Administrative Committee for the TIR Convention, 1975

**Accepted amendment proposals to the
Convention pending formal adoption**

Note by the secretariat

Sketch No. 9.4

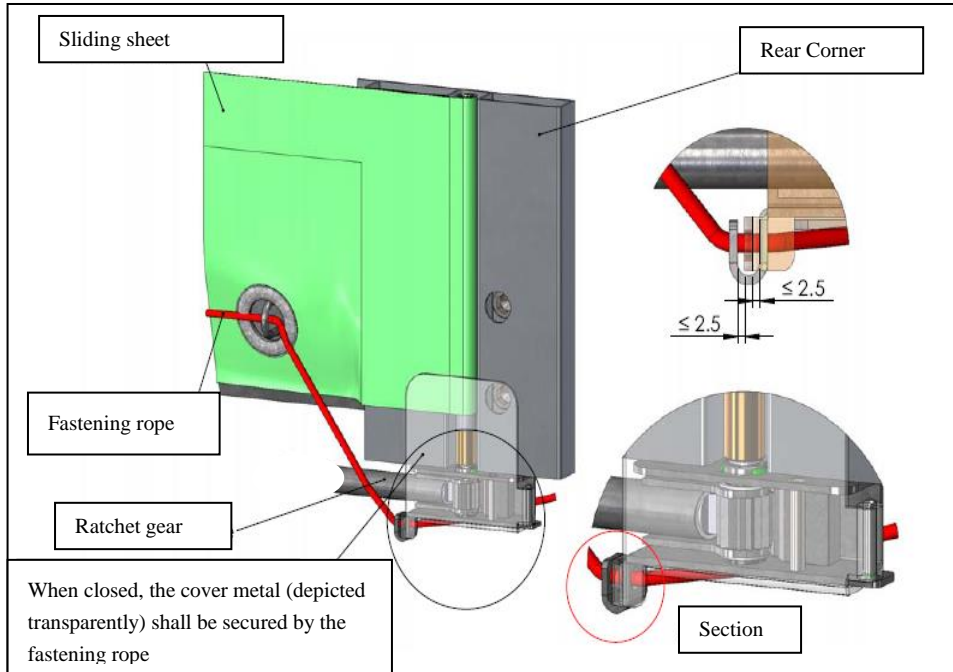
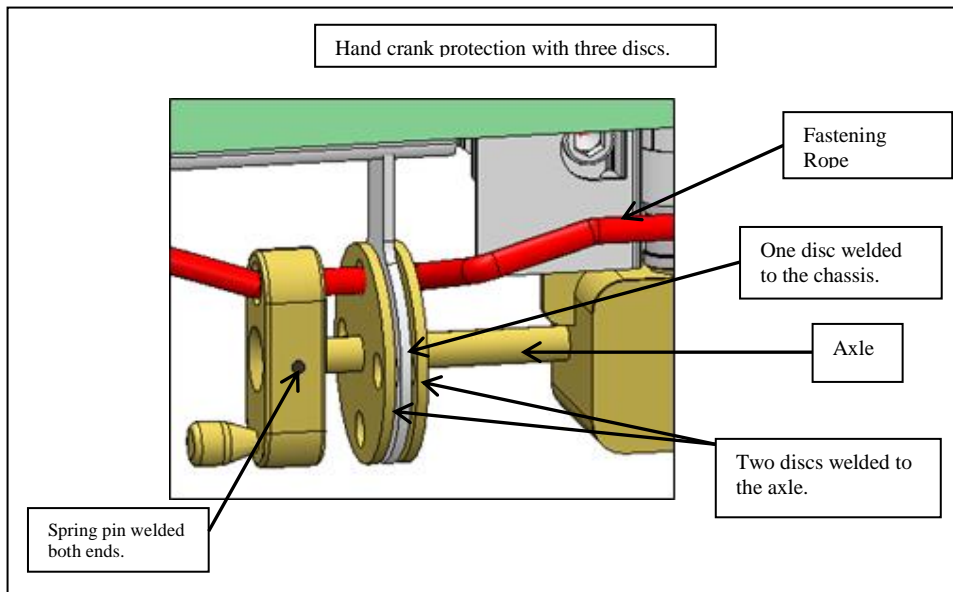
For the existing Sketch No. 9 *substitute*

To tighten the sliding sheets in the horizontal direction, a ratchet gear is used (normally at the rear end of the vehicle). This sketch shows two examples, (a) and (b), of how the ratchet or gearbox may be secured.

Sketch No. 9.5

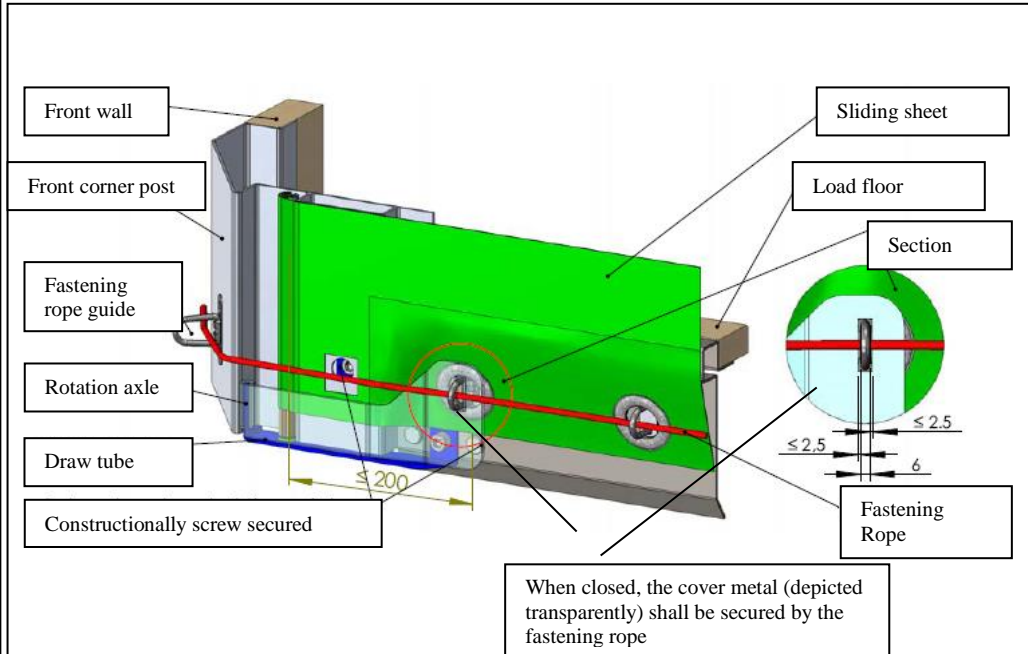
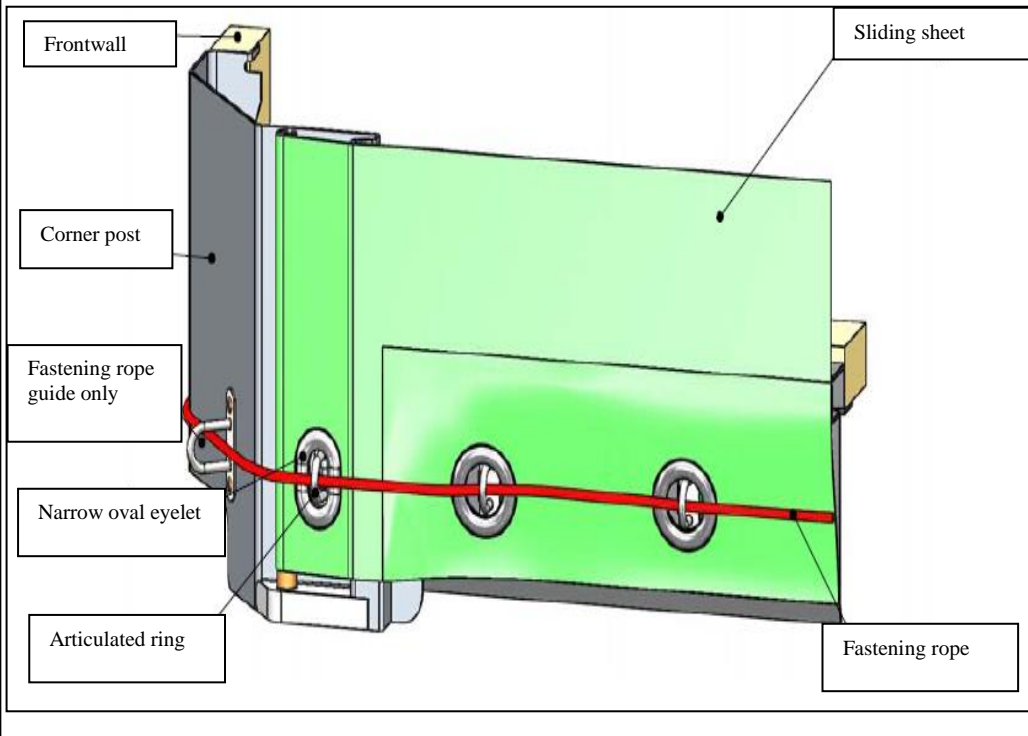
To fix the sliding sheet on the other side (normally the front of the vehicle), the following systems, (a) or (b), may be used.

Sketch No. 10

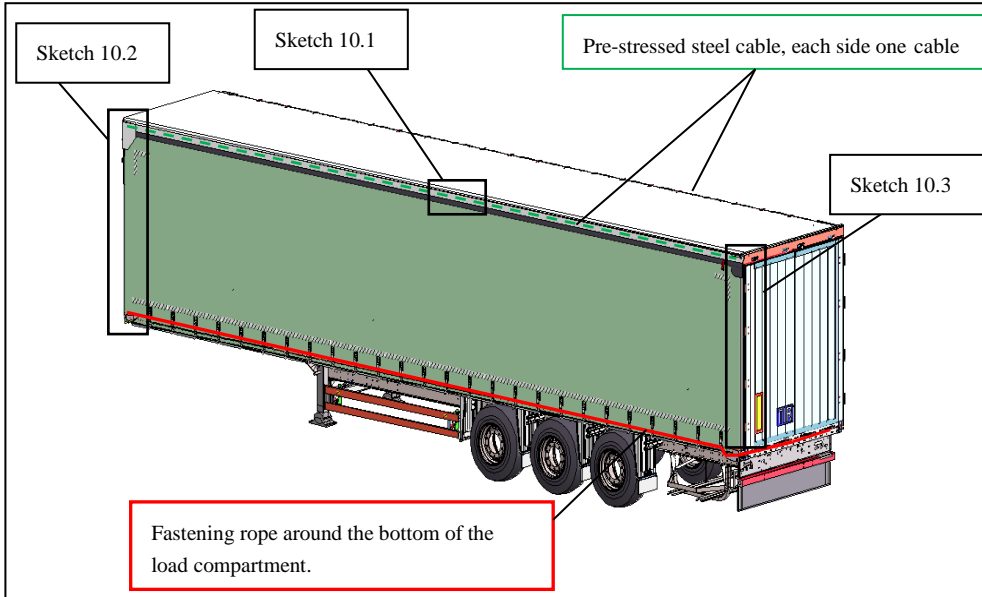
After new Sketch No. 9 insert

This sketch shows an example of a vehicle and the important requirements described in Article 5 of these Regulations.

Sketch No. 10.1

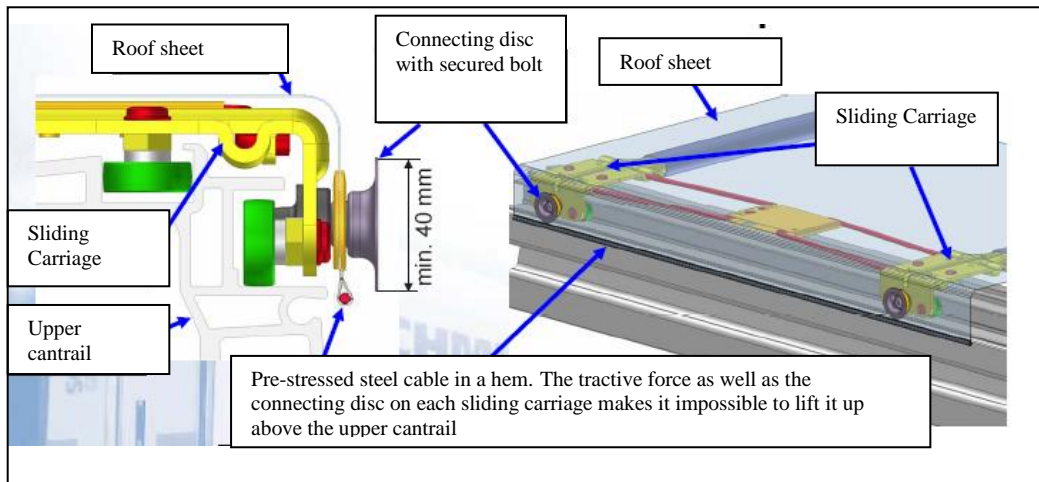
Two pre-stressed steel cables, embedded in a hem, are fixed on each side of the load compartment. This pre-stressed steel cable is fixed to the front (see sketch 10.2) and rear of the body (see sketch 10.3). The tractive force as well as the connecting disc on each sliding carriage makes it impossible to lift up the hem with the pre-stressed steel cable above the upper cantrail.

Sketch No.10.2

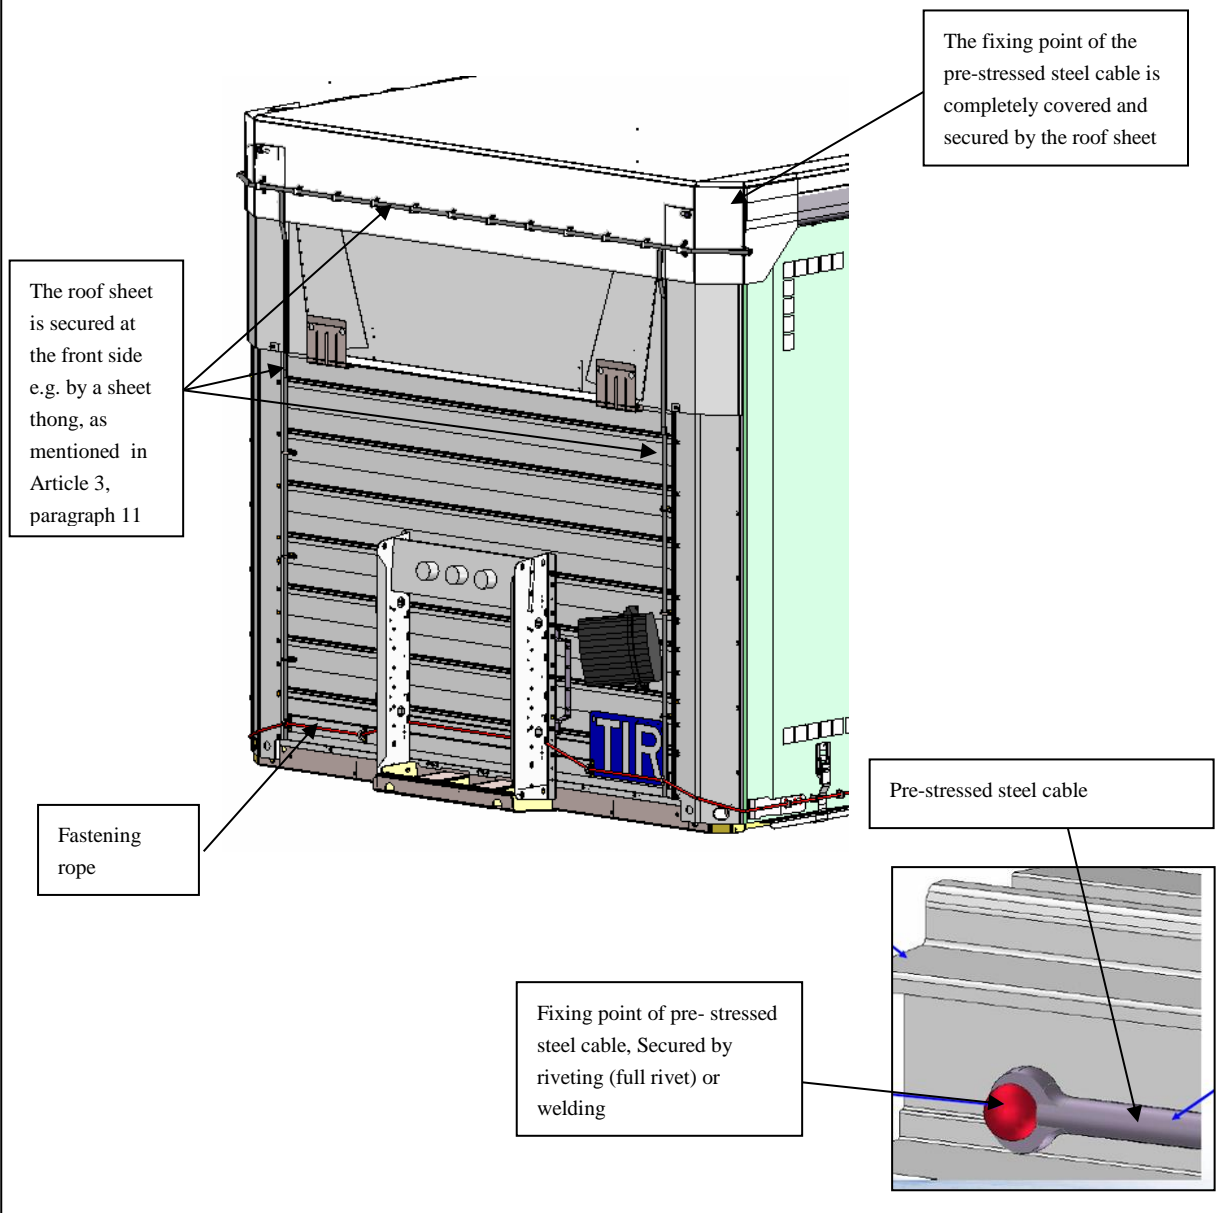
The sliding roof sheet shall overlap with the solid part of the roof at the front side of the load compartment, so that the roof sheet cannot be pulled over the top edge of the upper cantrail.

Sketch No.10.3

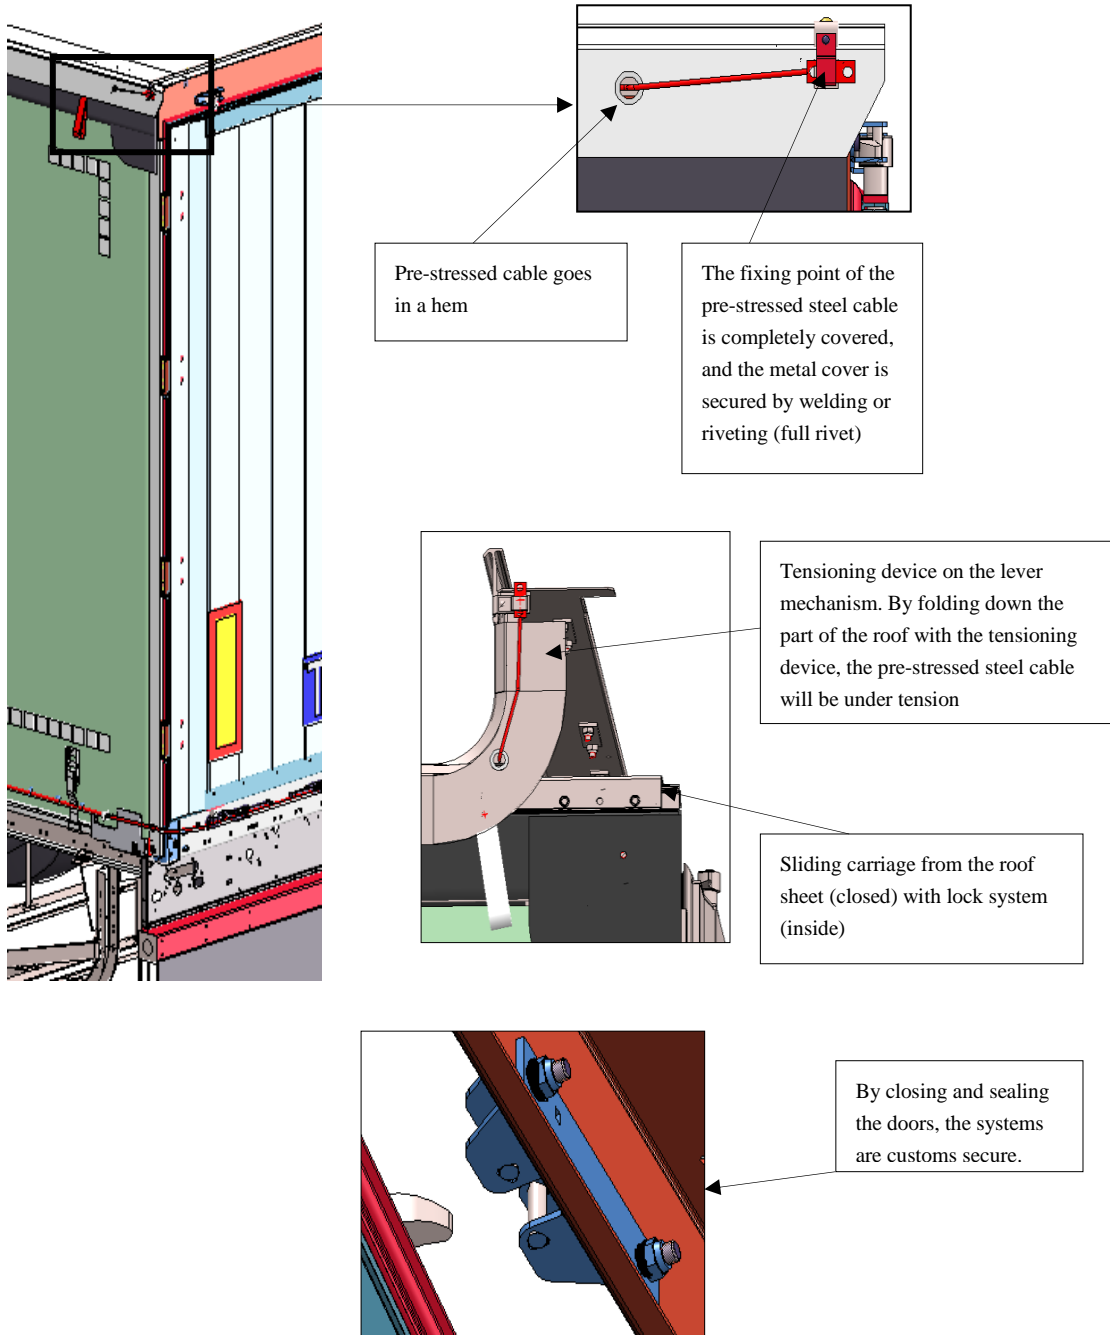
At the rear, a special device, such as a baffle plate, is fitted to the roof, preventing access to the load compartment, without leaving obvious traces when the doors are closed and sealed.

Sketch No. 9.4

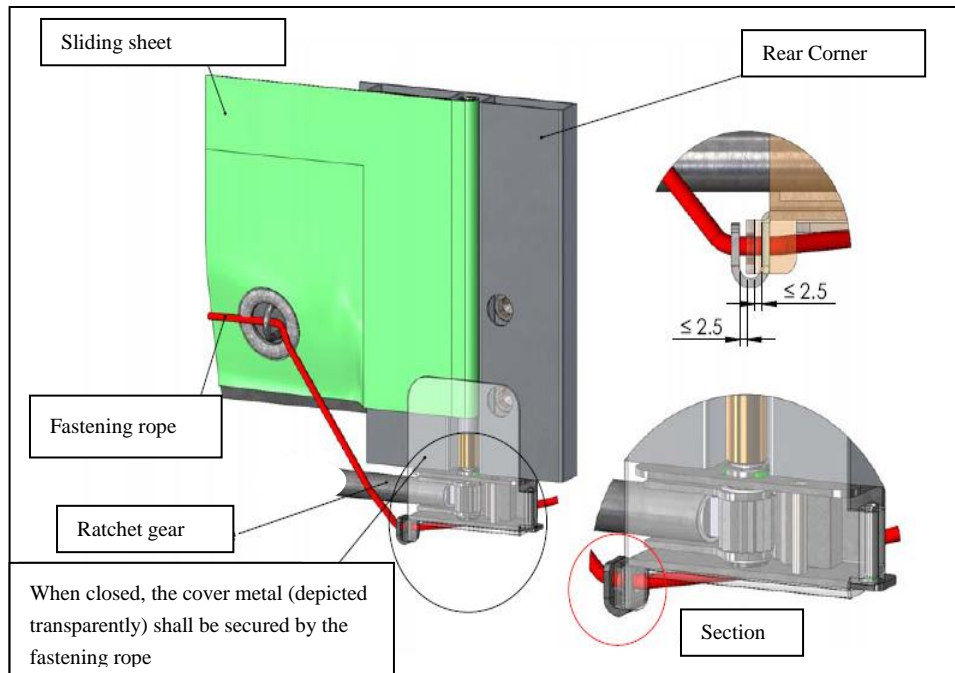
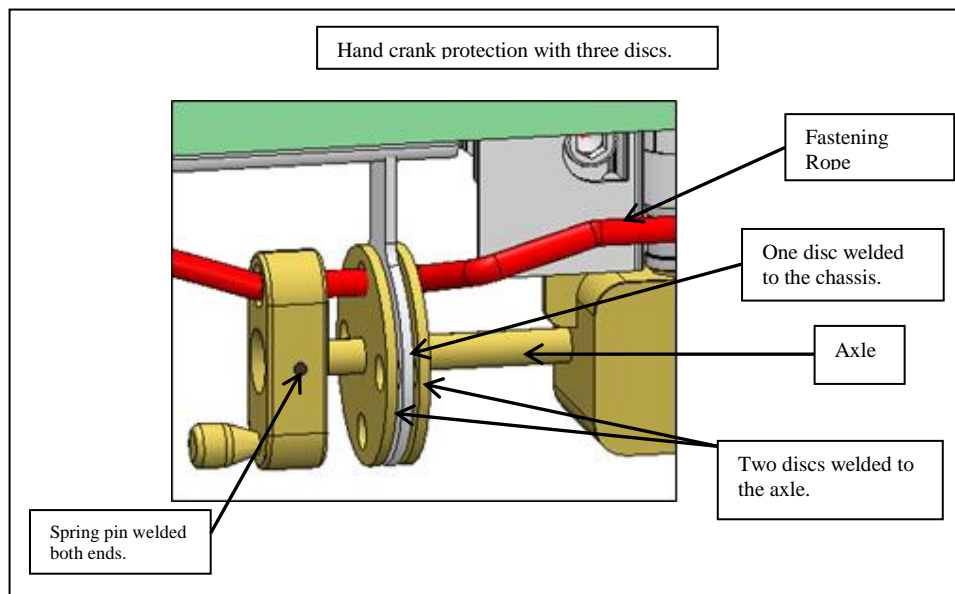
For the existing Sketch No. 9 substitute

To tighten the sliding sheets in the horizontal direction, a ratchet gear is used (normally at the rear end of the container). This sketch shows two examples, (a) and (b), of how the ratchet or gearbox may be secured.

Sketch No. 9.5

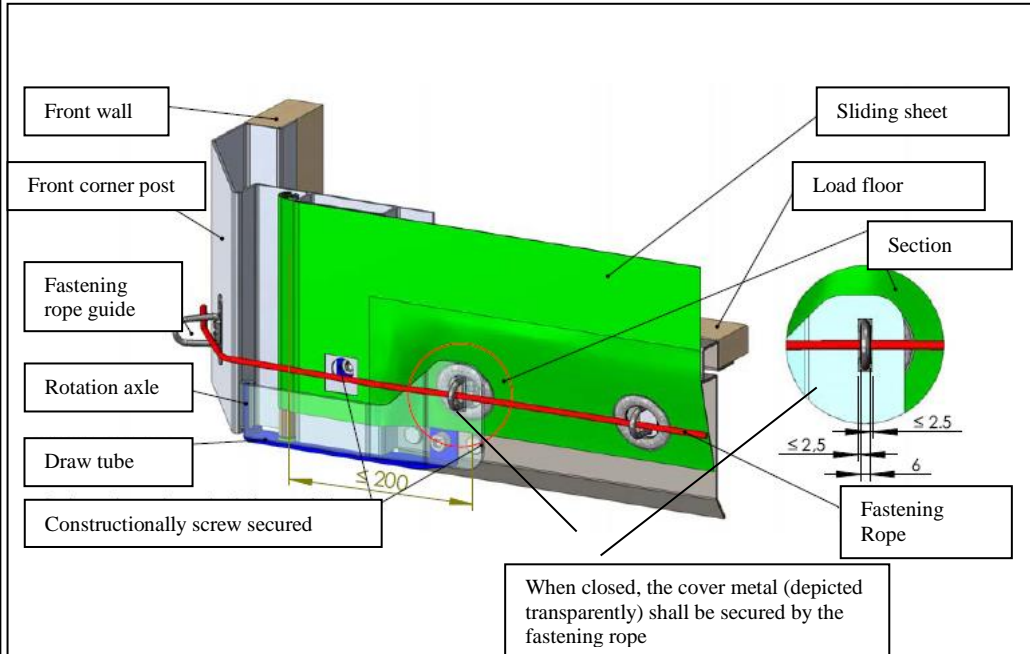
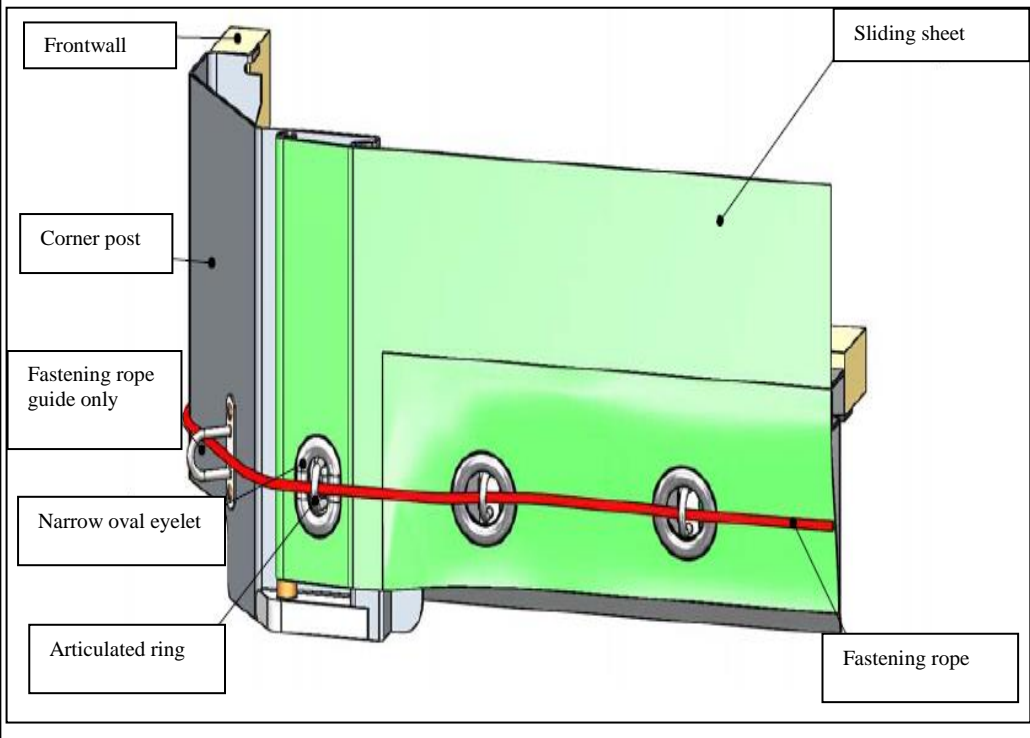
To fix the sliding sheet on the other side (normally the front of the container), the following systems, (a) or (b), may be used.

Sketch No. 10

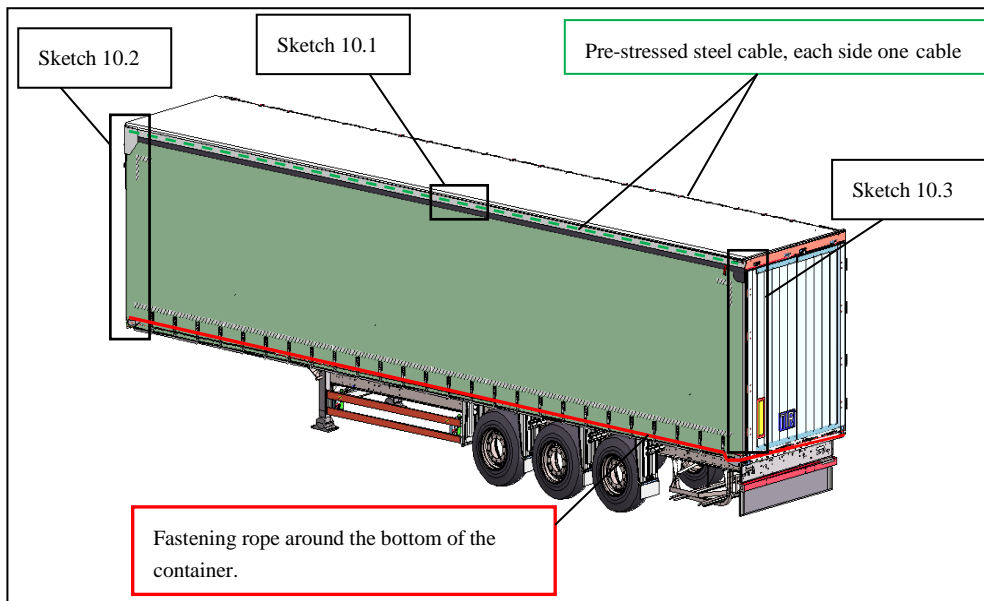
After new Sketch No. 9 insert

This sketch shows an example of a container and the important requirements described in Article 6 of these Regulations.

Sketch No. 10.1

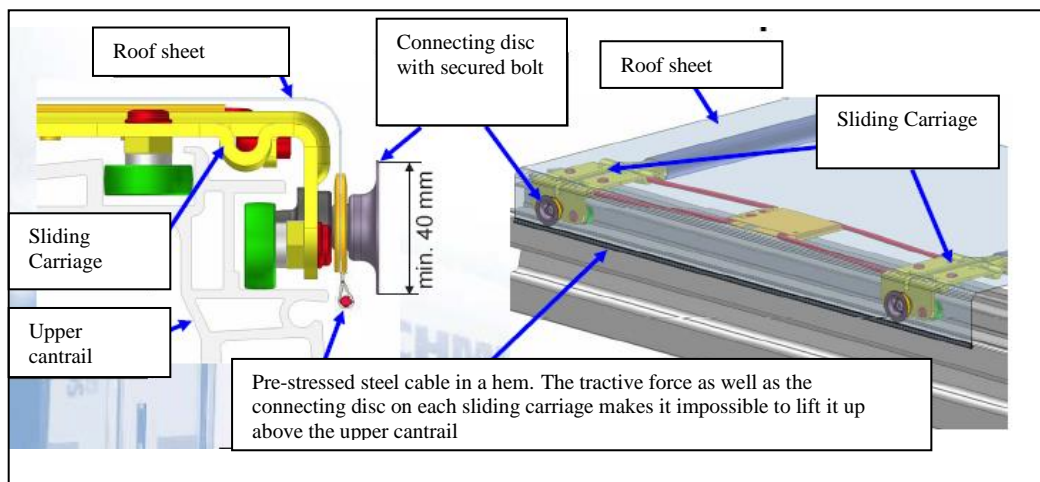
Two pre-stressed steel cables, embedded in a hem, are fixed on each side of the container. This pre-stressed steel cable is fixed to the front (see sketch 10.2) and rear of the body (see sketch 10.3). The tractive force as well as the connecting disc on each sliding carriage makes it impossible to lift up the hem with the pre-stressed steel cable above the upper cantrail.
